E5071C-39

E5071C - ENA Series Network Analyzer, 9 kHz to 20 GHz

Black screen is shown during boot-up due to DSP failure

How to identify E5070-66671 Assembly date code

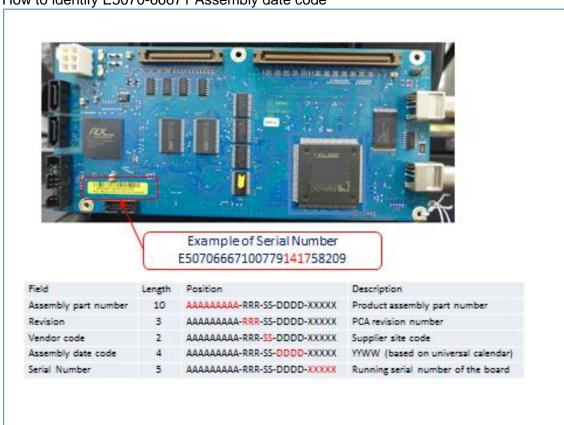
One of two symptoms is shown for this DSP board issue. This issue is found on specific DSP board assembly date code. (See below how to identify the date code)

Do not use the DSP board with Assembly date code 1417 for repair.

Replace with DSP board and perform Post-Repair procedure. (For more details, see the E5071C Service Guide.)
